AGENDA
BAINBRIDGE ISLAND ROAD END ADVISORY COMMITTEE
SPECIAL MEETING
TUESDAY, SEPTEMBER 30, 2014 4pm to 5:30pm
CITY HALL

Fletcher Landing Proposed Road End Improvements Assessment

AECOM
710 Second Avenue, Suite 1000
Seattle, WA 98104

September, 2014

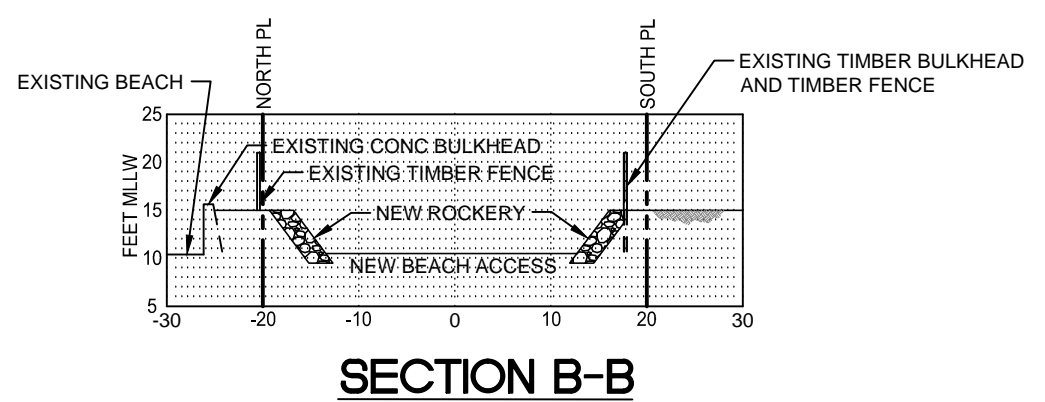
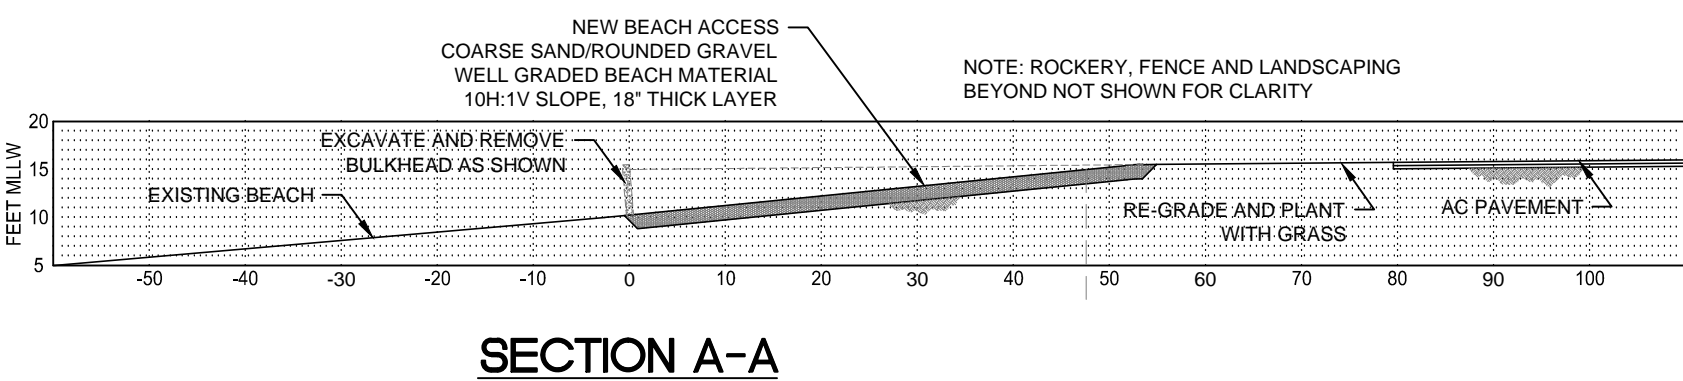
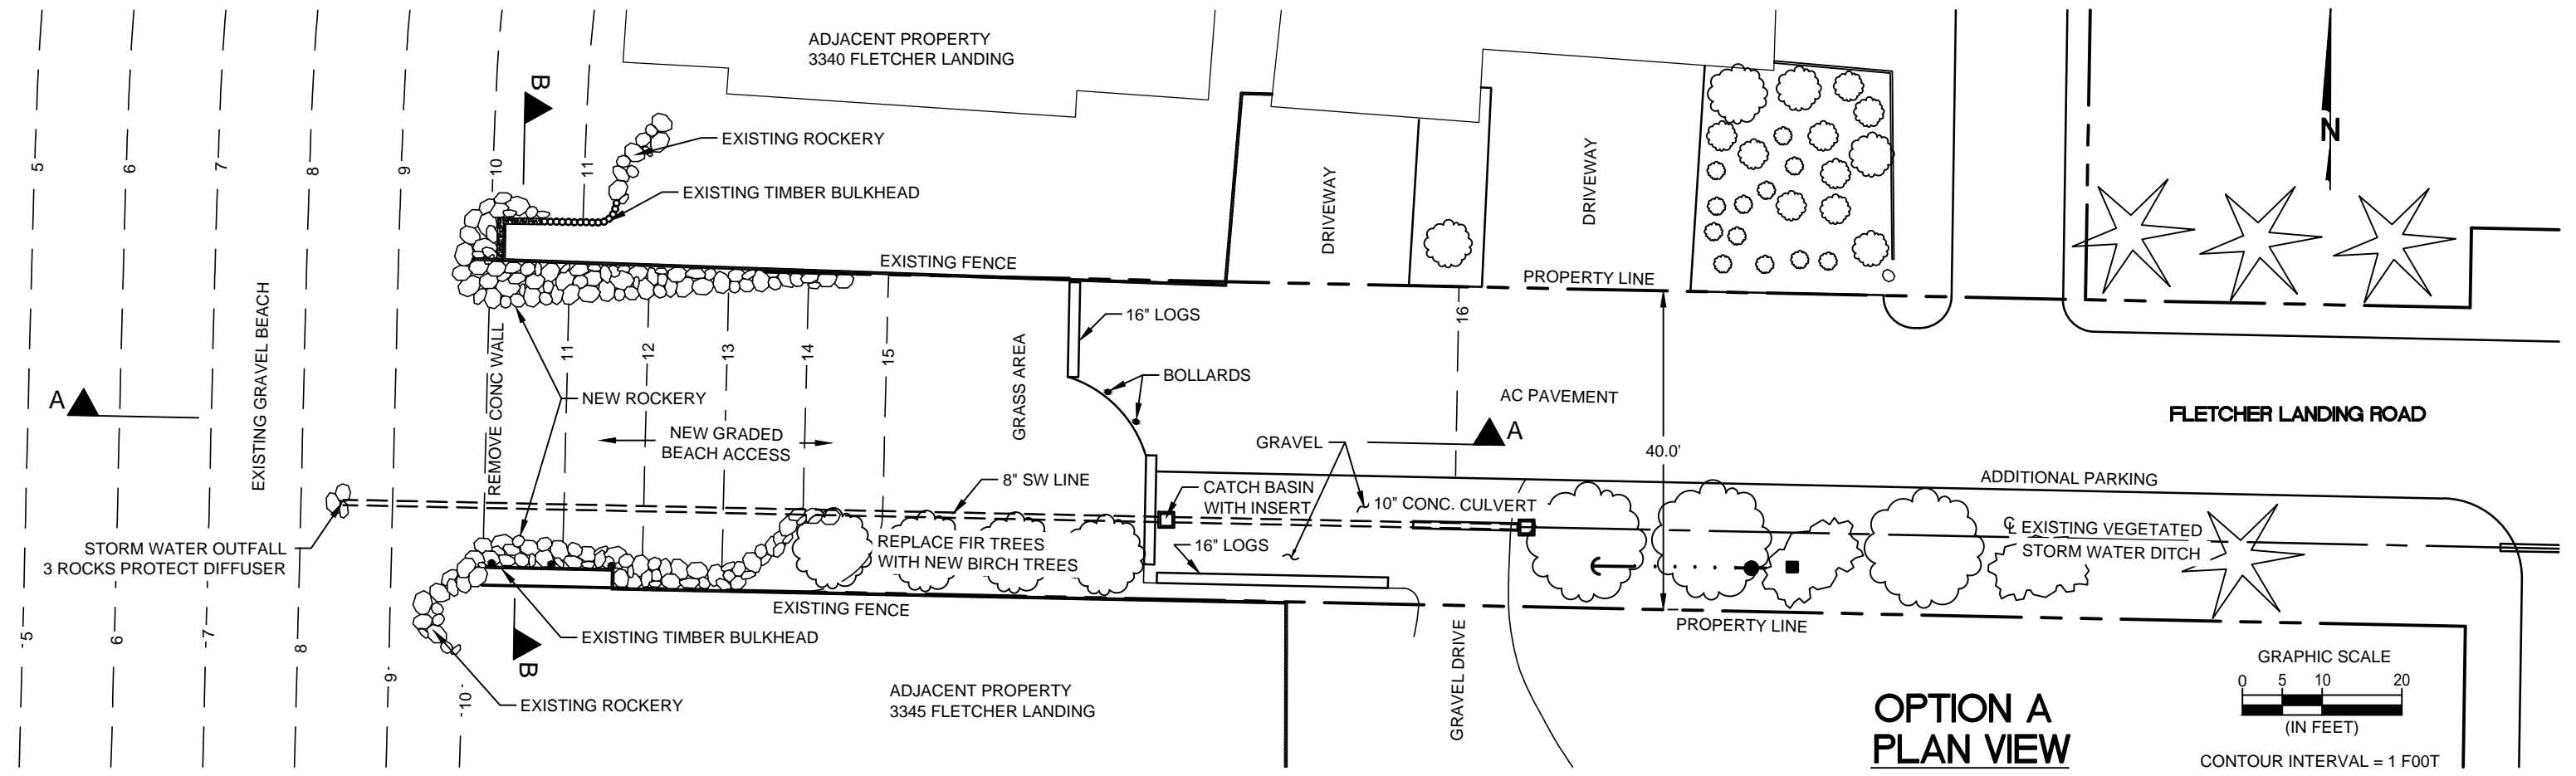
This option (Figure 7) provides the widest beach access with limited new upland landscape areas. The bulkhead is removed from the northern property line to its southern end. Existing grade is excavated to provide beach access by

carrying the existing beach up slope to tie into the existing upland elevation, creating additional beach area. Concept drawings show this beach extension at an approximate 10H:1V slope (final stable slope determined in design). It is assumed that material for the new extension of beach will be sized appropriately to blend with fronting beach and remain stable. Thickness of the new beach material layer is assumed to be 18 inches. New stone rockeries will protect the cut slopes along the north and south margins of excavation and tie into existing rockery to the south and bulkhead to the north.

This concept basically creates a well-protected pocket beach. Considering elevation range of new access beach and level of protection, erosion/stability of beach profile is not anticipated to present a significant design issue (for any of the options). Demolishing the seawall removes a vertical structure from the upper intertidal zone; this should provide some limited improvement in erosional conditions during the higher water levels by eliminating a reflecting surface for wave energy. No negative impact to adjacent shorelines would currently be anticipated (for any of the options).

Stormwater management for this option includes transitioning from the current open ditch to an 8 inch buried line at the 10 inch driveway culvert. The new pipe would enter a new catch basin with insert and then a buried discharge line extends west down the new access ramp and out to a beach discharge point at approximately elevation 8 feet within the intertidal zone. Additional more detailed design analysis is necessary to determine the area drained and amount of water to be conveyed during a design storm, and to determine the feasibility of an open vegetated bio-swale type system. Discharge at the rockery with an energy diffuser should also be explored as an alternative to the beach discharge.

This option provides two parking spaces as part of the street end redevelopment and, as with other options, there is room to park up to 4 vehicles along the south side of the road east of the gravel driveway.

Option A maximizes beach access and has the lowest level of park like amenities and landscape features. Maintenance for this alternative is anticipated to be minimal.

This alternative (as depicted) brings excavation and rockery construction right up to, or very close to, the adjacent property lines and property owners’ fences. Lacking information on fill/sub-grade material appropriate measure should be taken in design and construction to insure the integrity of fences and adjacent properties is maintained.

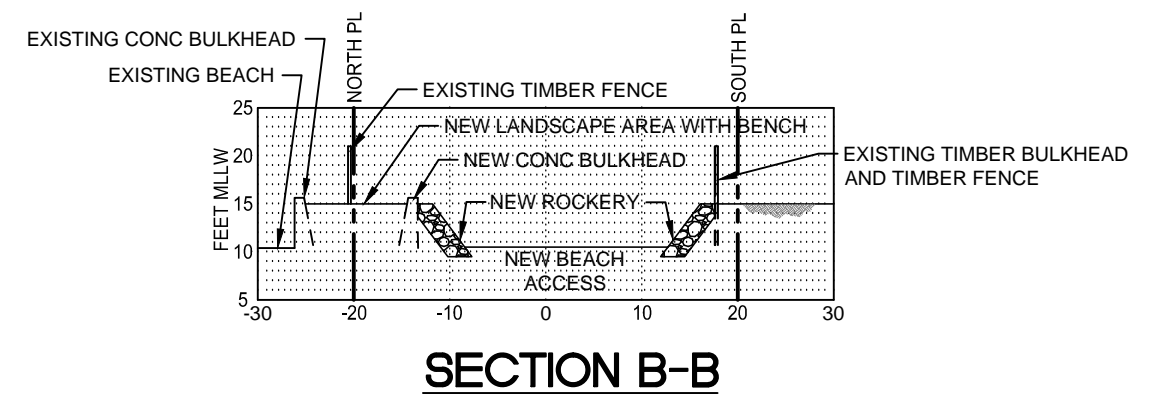
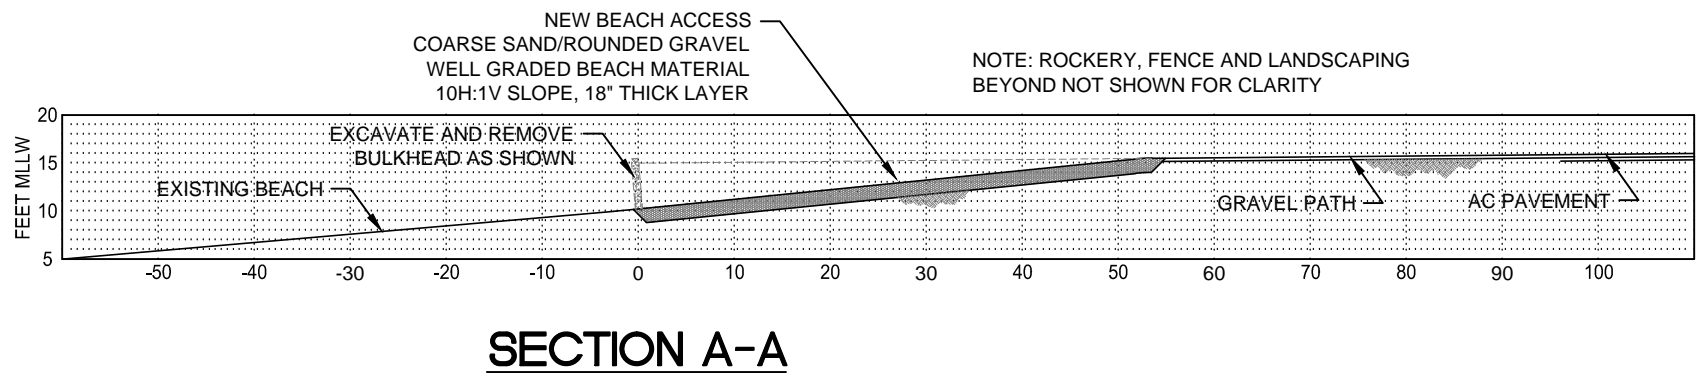
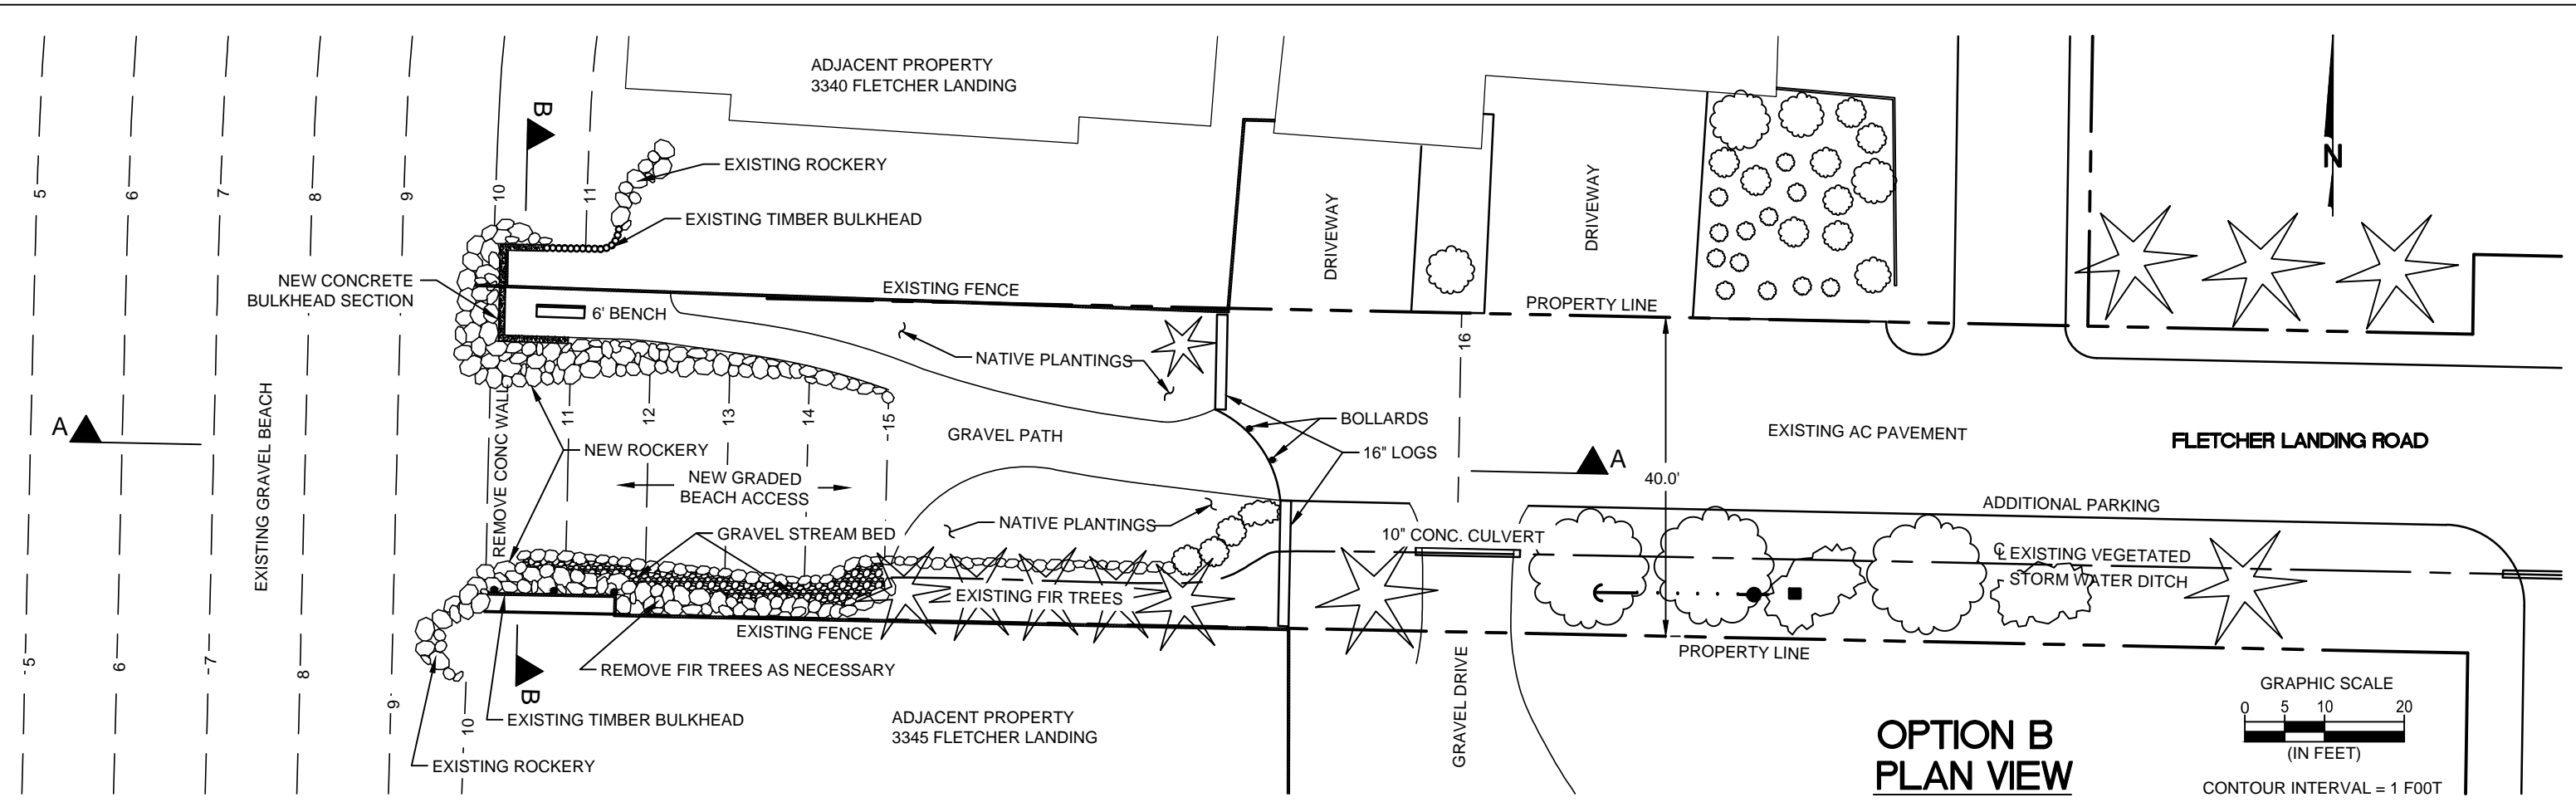
Option B (Figure 8.) follows the same basic concept as Option A but reduces the width of the beach access and provides a narrow landscaped area with a path and viewing bench at an upland grade along the northern edge of the site. A concrete bulkhead is constructed at the shoreside end of the viewing area.

Based on the concept sketch, it appears that Option B transitions the open stormwater ditch into an artificial gravel stream bed integrated into the rockery close to its base and discharges to receiving water. This is an interesting feature, but as with the other options, additional more detailed design analysis is necessary to determine the area drained and amount of water to be conveyed during a design storm, and the feasibility and compliance of the concept.

The concept sketch showed no parking spaces being created at the new street end but as with other options there is room to park up to four vehicles along the south side of the road east of the gravel driveway.

Option B reduces beach access width in order to provide a minimal level of park-like amenities, a viewing bench and landscape features. Maintenance for this alternative is anticipated to be minimal, limited to the care of landscaping.

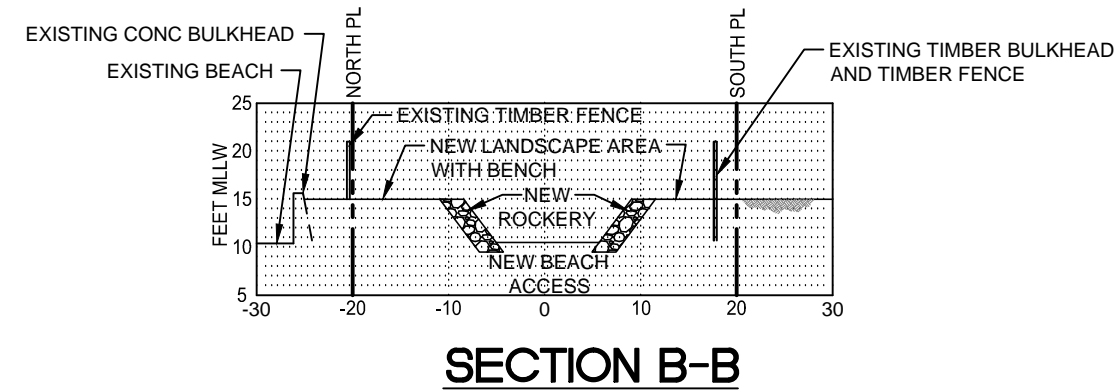
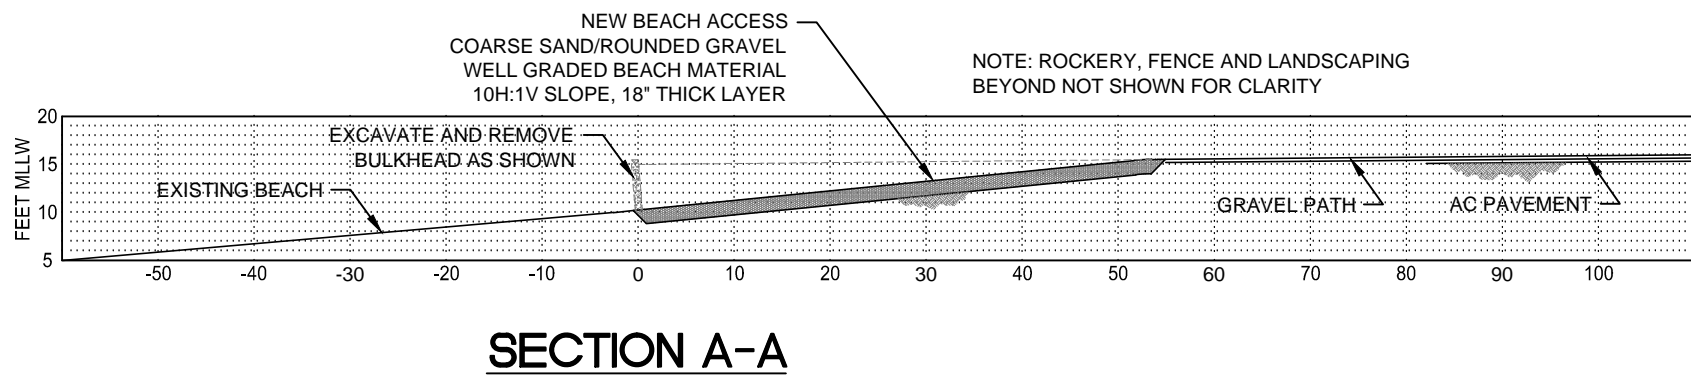
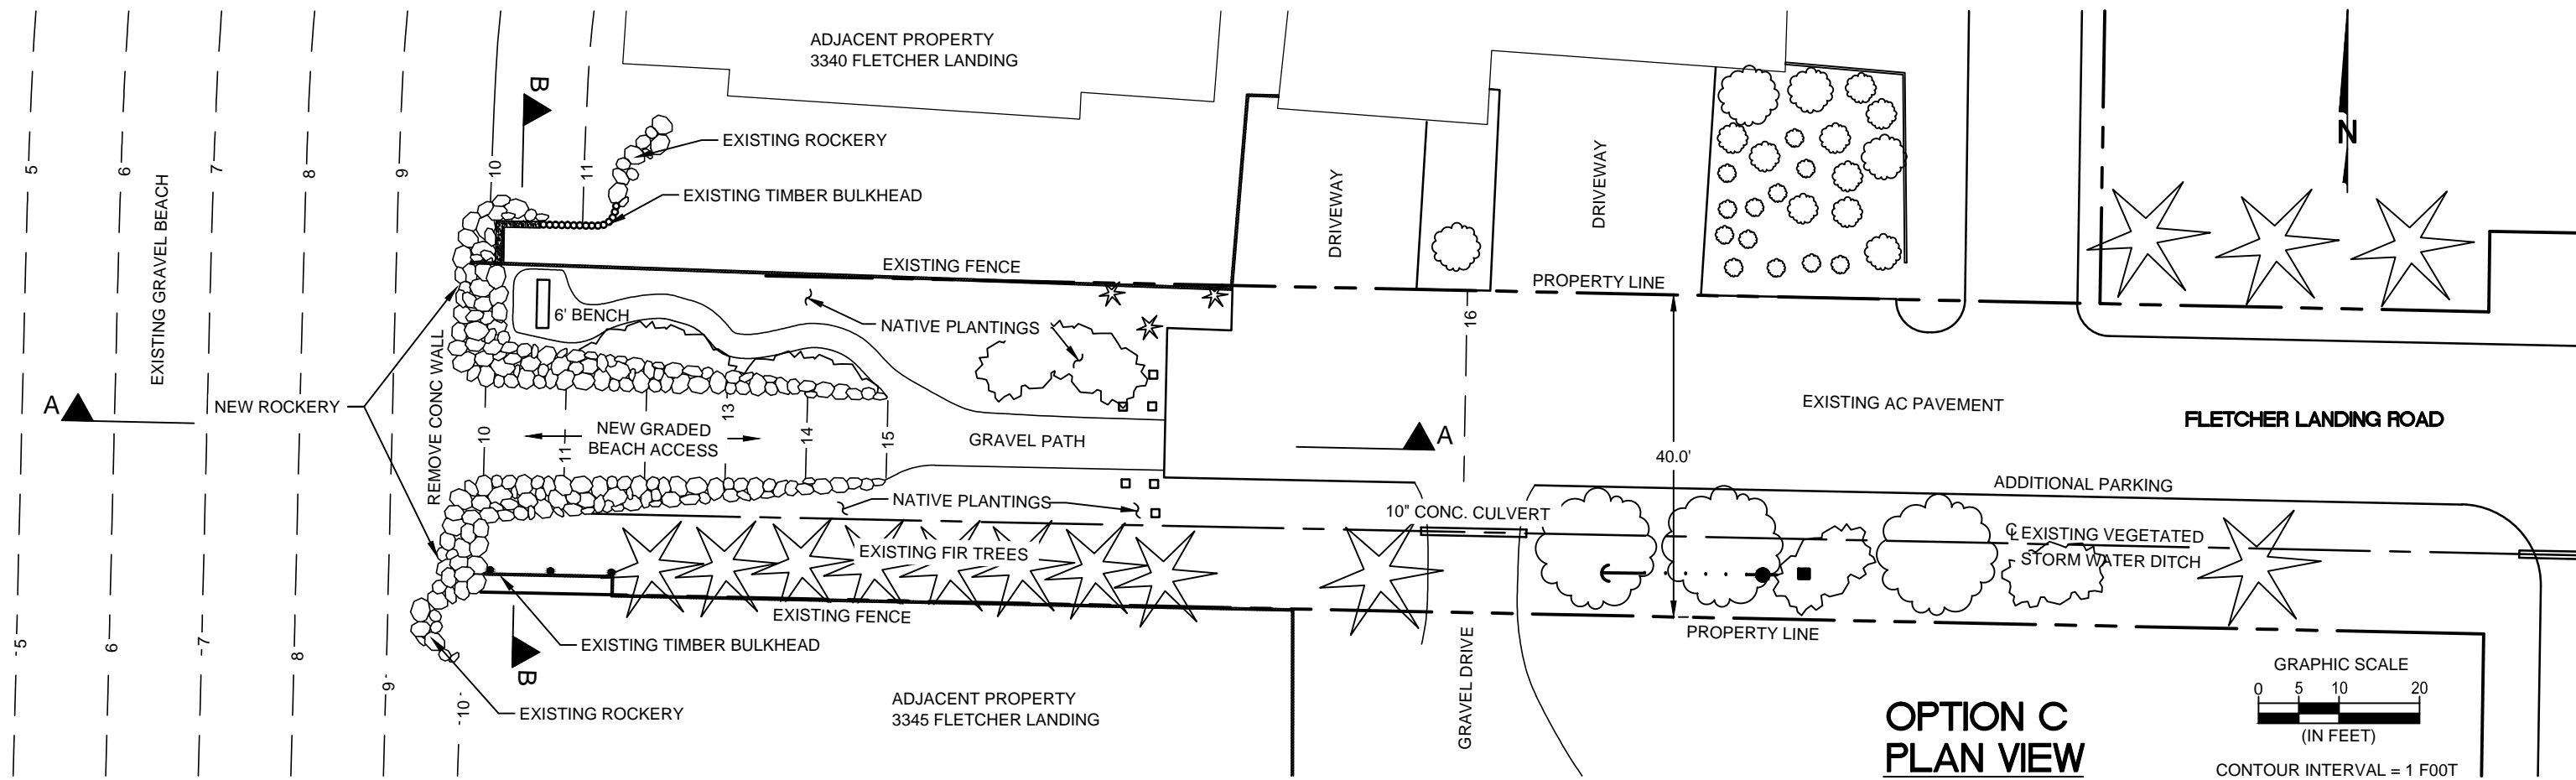
Option C (Figure 9.) follows the same basic concept as Option B but further reduces/minimizes the width of the beach access and provides a greater landscaped area, along the northern and southern edges of the site. The northern landscape area includes a path and viewing bench at upland grade.

Based on the concept sketch the intended stormwater system could not be determined, it appears that the storm water conveyance may be a buried pipe system but there is no notation or catch basin structures shown so this was not assumed. Stormwater discharge is at the rockery.

The concept sketch showed no parking spaces being created at the new street end but designated three vehicle spaces along the south side of the road east of the gravel driveway. In this concept the spaces are shown as developed with the road edge offset about 4 feet. The existing drainage ditch would have to be shifted or buried conveyance piping with catch basin(s) installed to safely accommodate this configuration.

Option C minimizes beach access width in order to maximize the level of park-like amenities and landscape features. Maintenance for this alternative is anticipated to be minimal, limited to care of native vegetation landscaping.
